## ADDENDUM THREE

Ivy Flats  
205 Rumely Street  
LaPorte, IN 46350

Commission No.: F22131

Addendum Date: 29 April 2024

REVIEWED BY: TDE  
DATE: 2024-03-13
- C101
- DEMOLITION PLAN

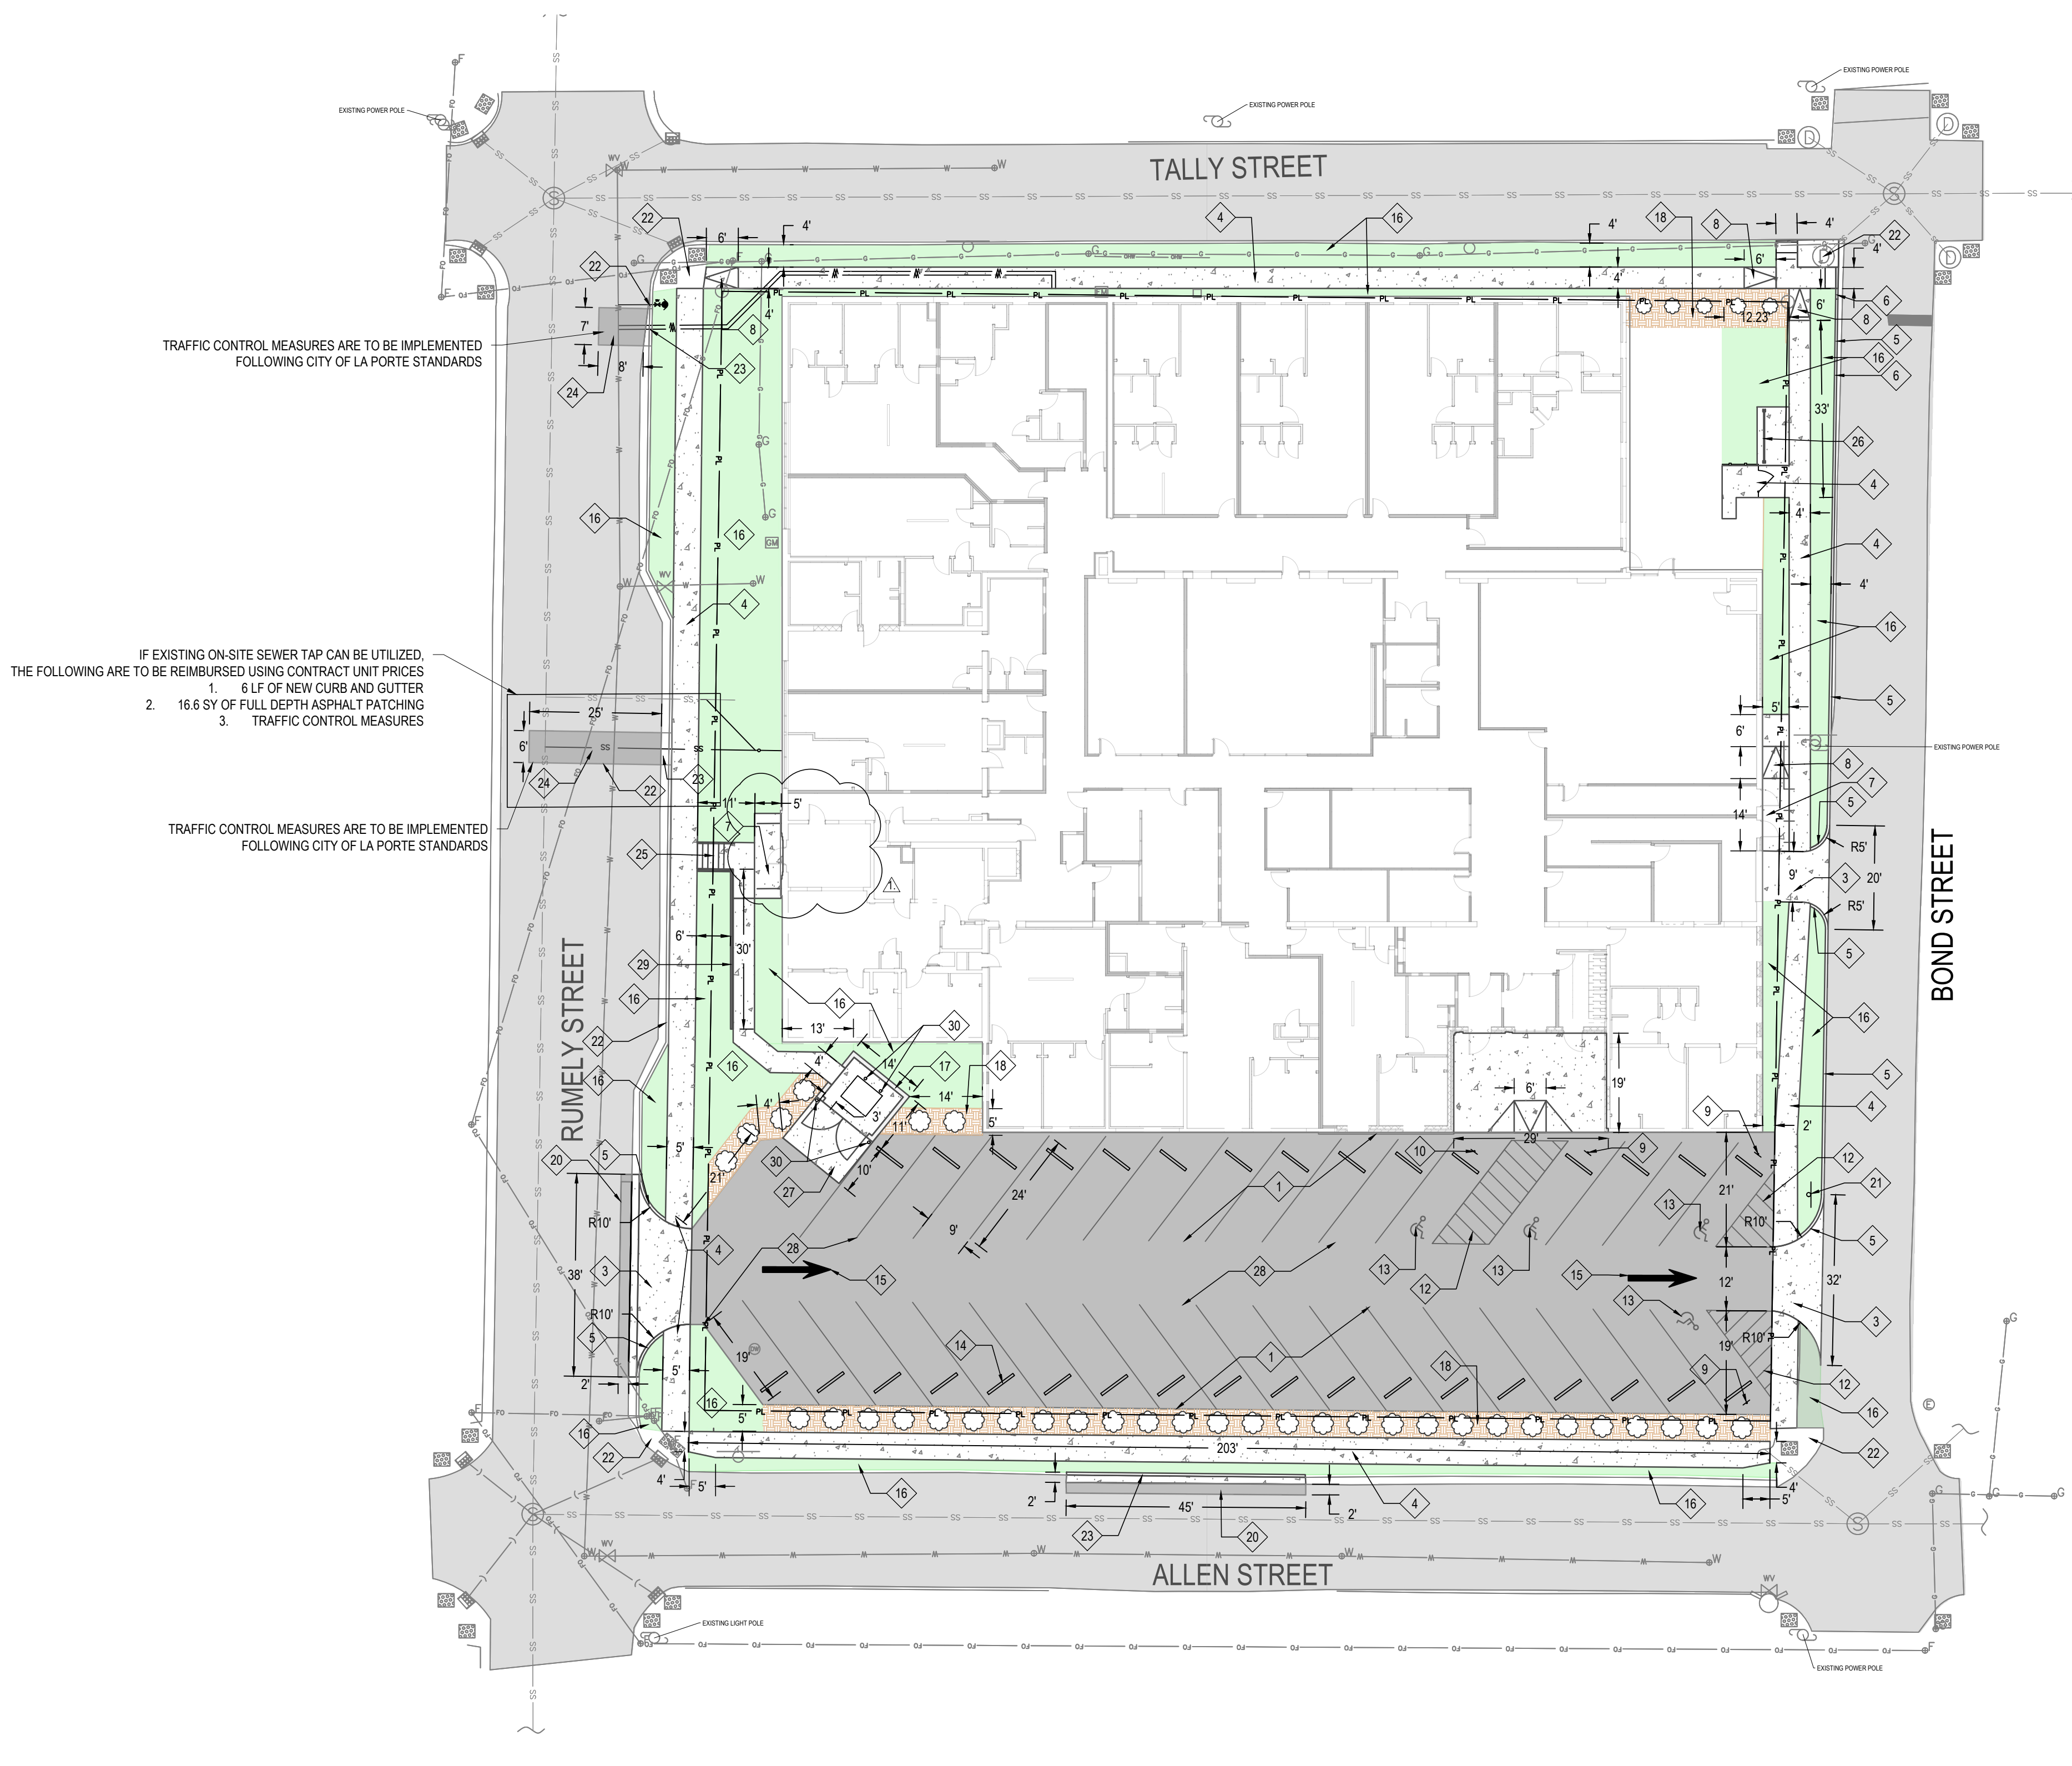
- TYPICAL SITE DEMOLITION NOTES: **MODIFY** Typical Site Demolition Note #9 to state:  
“9. INTENTIONALLY OMITTED.”
- 1/C101: **REMOVE** Typical Site Demolition Note #9 from the drawing.

# C300

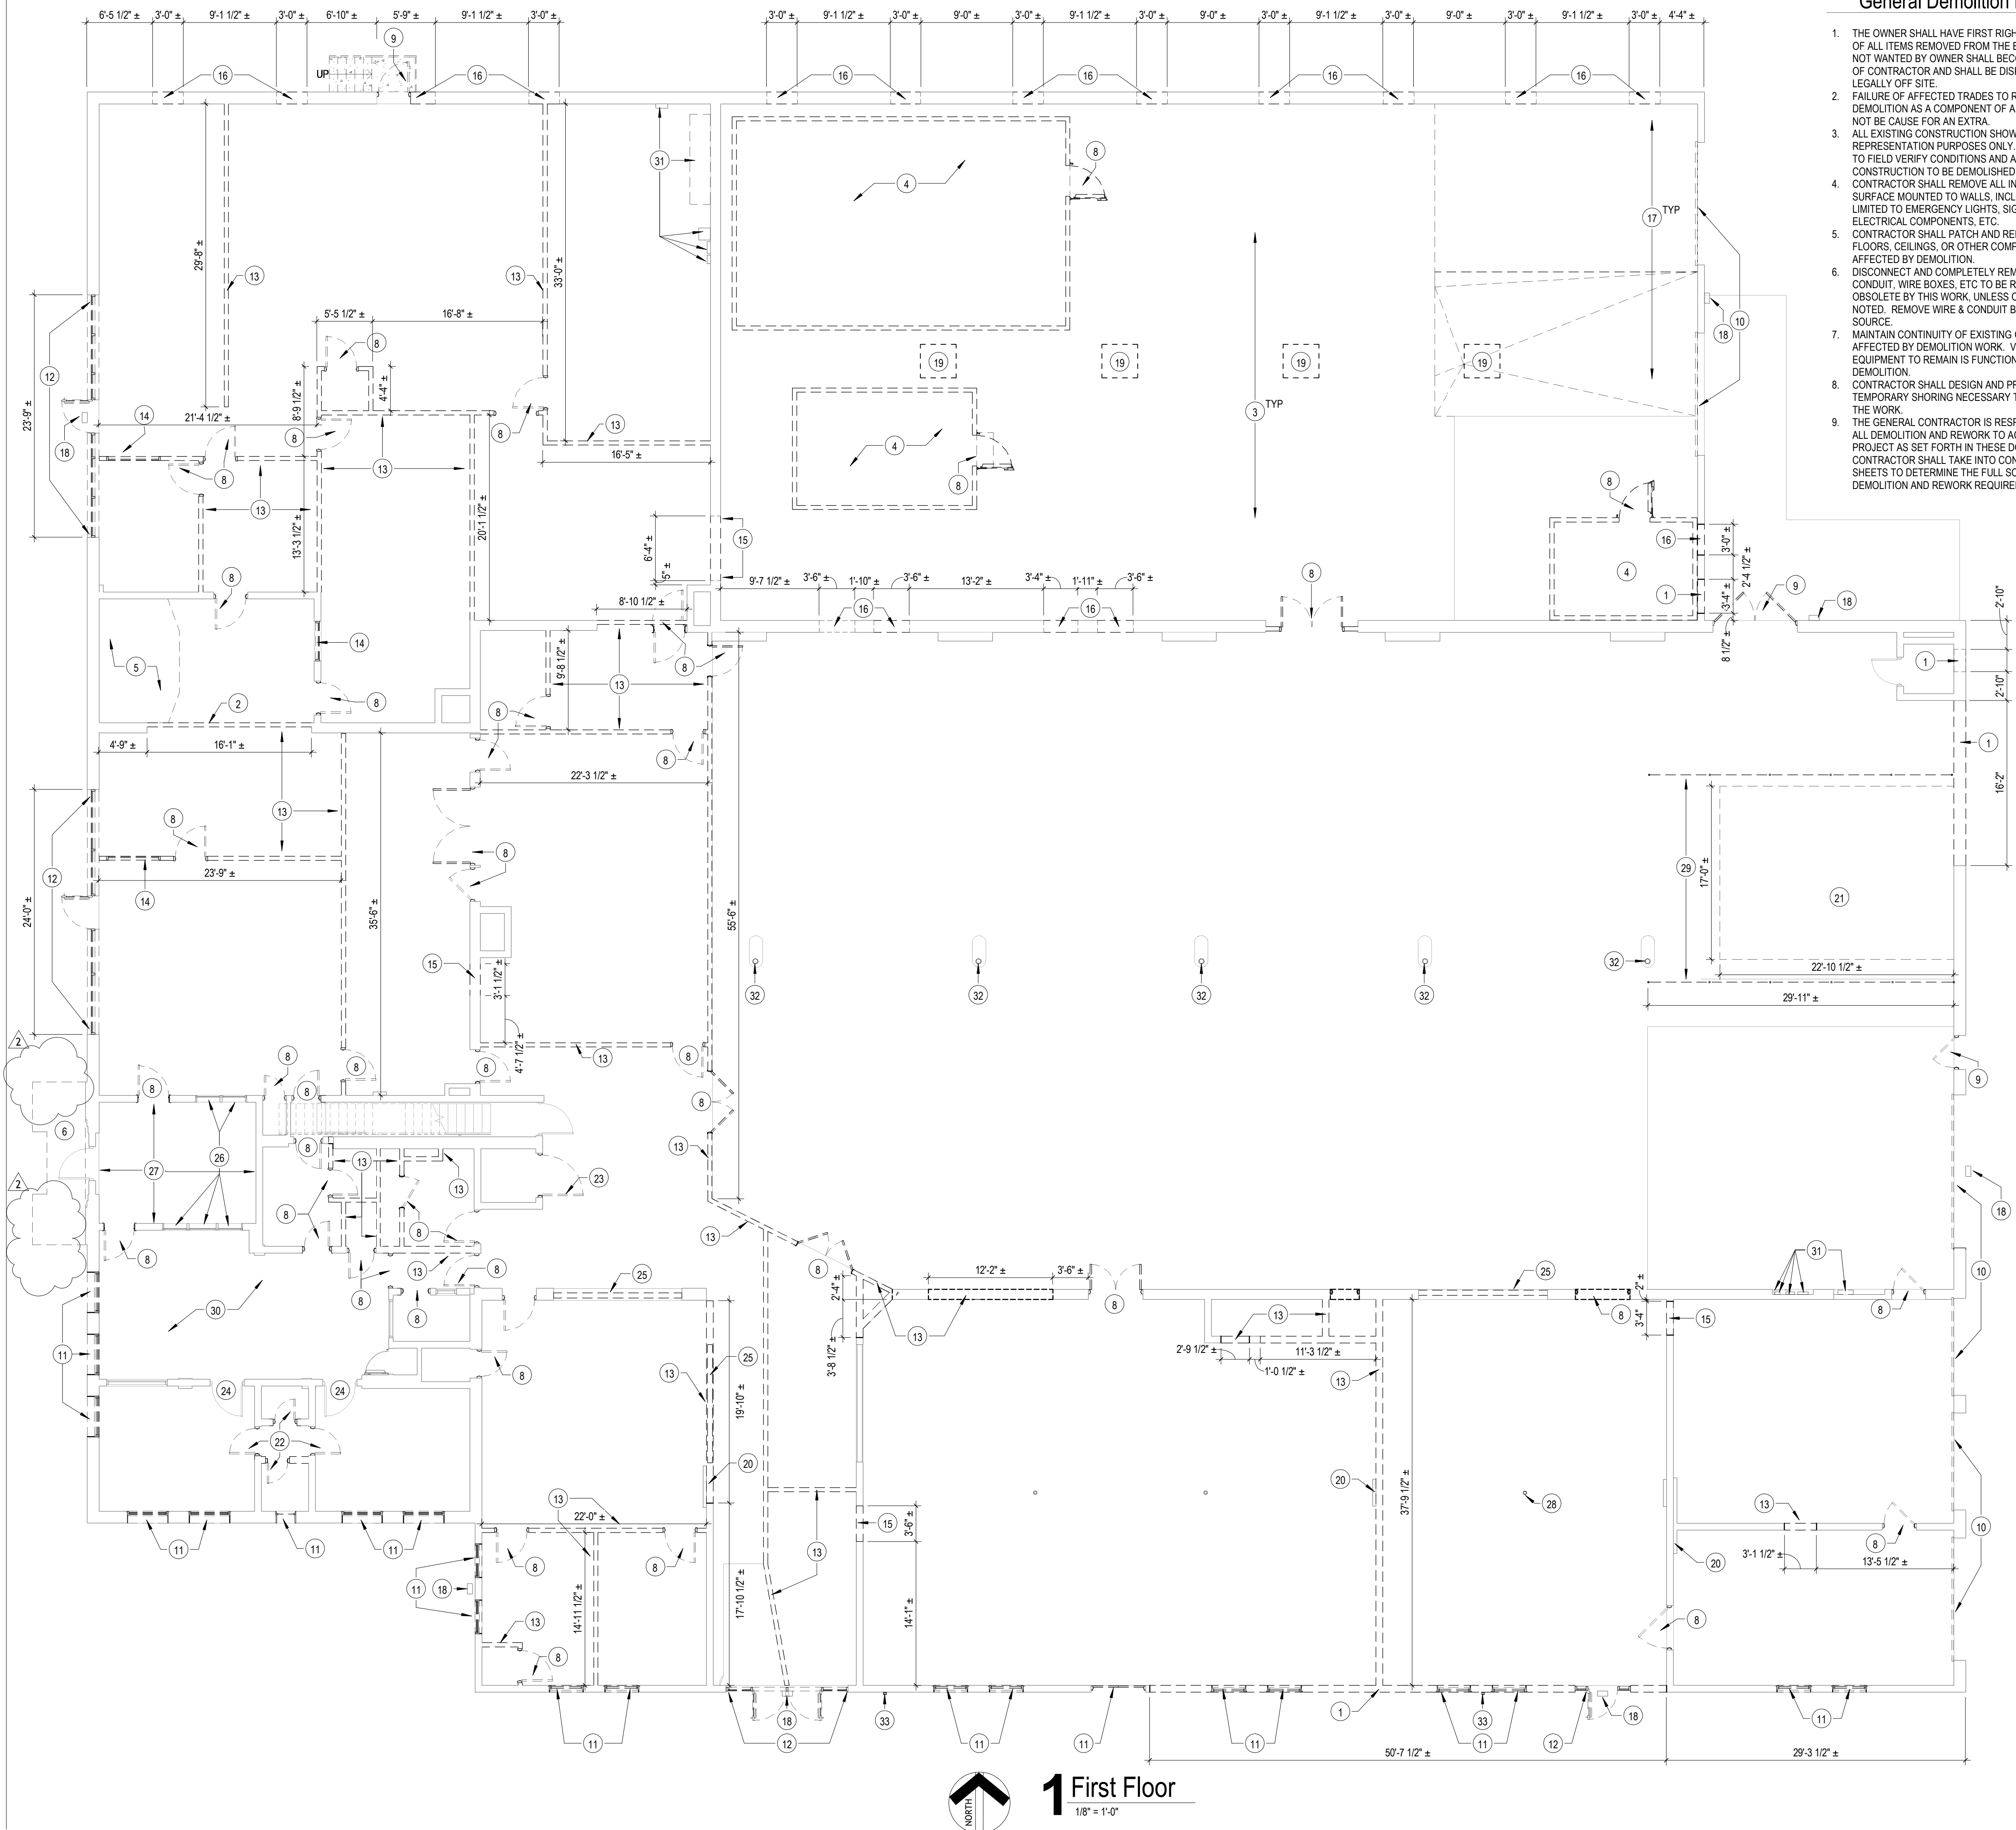
- 1/C300: Information has been **ADDED** to the drawing for downspout boots, piping route, and distribution to storm drain.

# D102

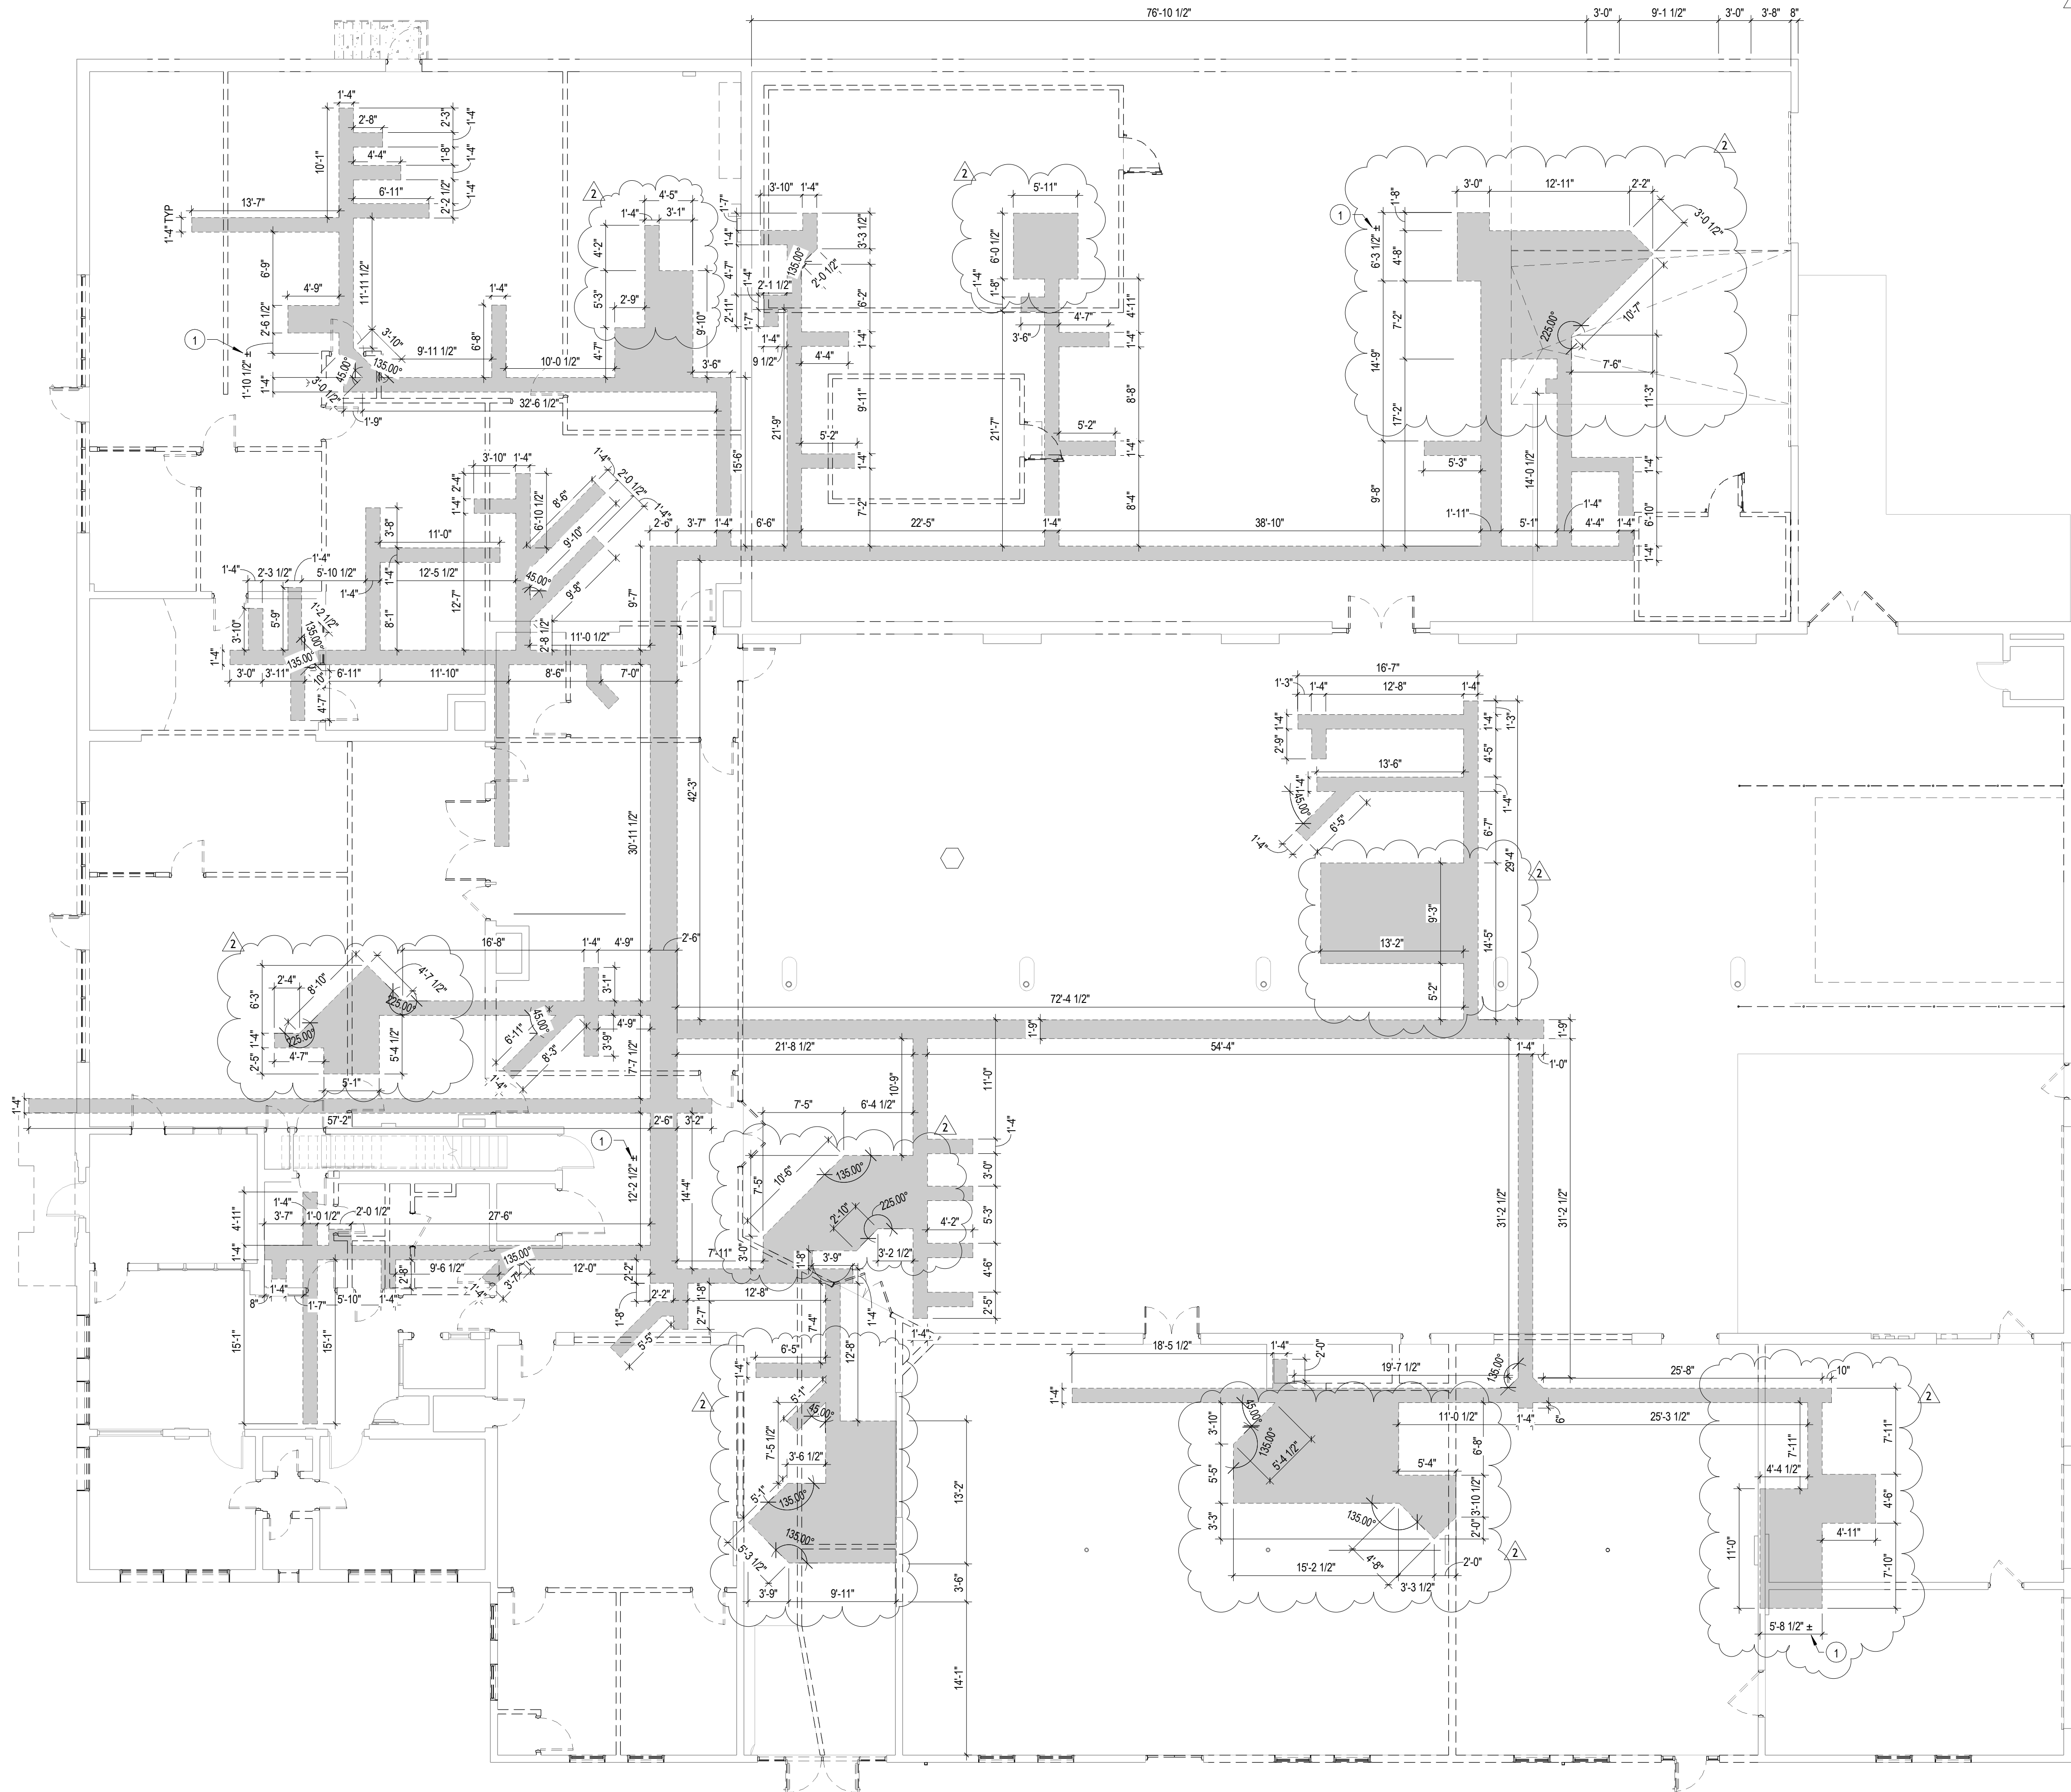
- GENERAL DEMOLITION NOTES:
  - **ADD** General Demolition Note #14 stating:  
“ALL EXISTING FLOORS, WITH THE EXCEPTION OF TERRAZZO, ARE TO BE DEMOLISHED.”
  - **ADD** General Demolition Note #15 stating:  
“ALL EXISTING CASEWORK IS TO BE DEMOLISHED.”
